STAFF REPORT: 03/25/2025 REGULAR MEETING

APPLICATION NUMBER: HDC2025-00011

ADDRESS: 2010-2040 MICHIGAN AVE.

SCOPE: CONSTRUCT PARKING LOT AND TRASH ENCLOSURE

Figure 4, 1884 Sanborn, Vol 1., 27: Red box shows parcels at 2010-2040 Michigan with brick commercial buildings at the east and west edges of the site.

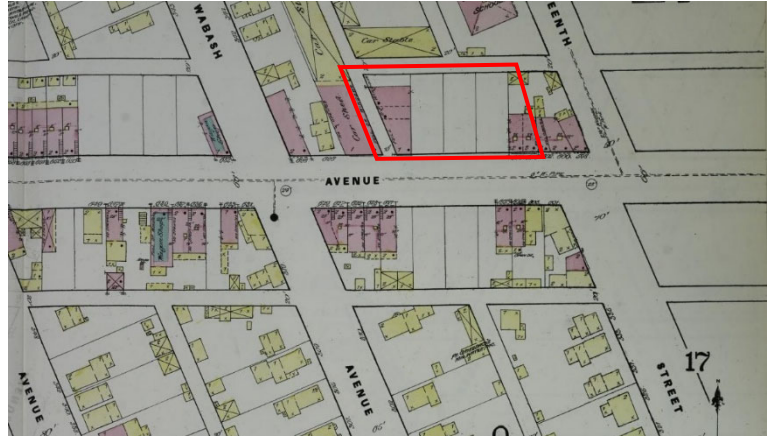
- Staff reviewed Sanborn maps dating from 1884 to 1951 and found that while the east and west parcels of the site had buildings nearly occupying the extent of their parcels, 2-3 central parcels were nearly vacant during Corktown's period of significance. (*See figures 4-6.*)
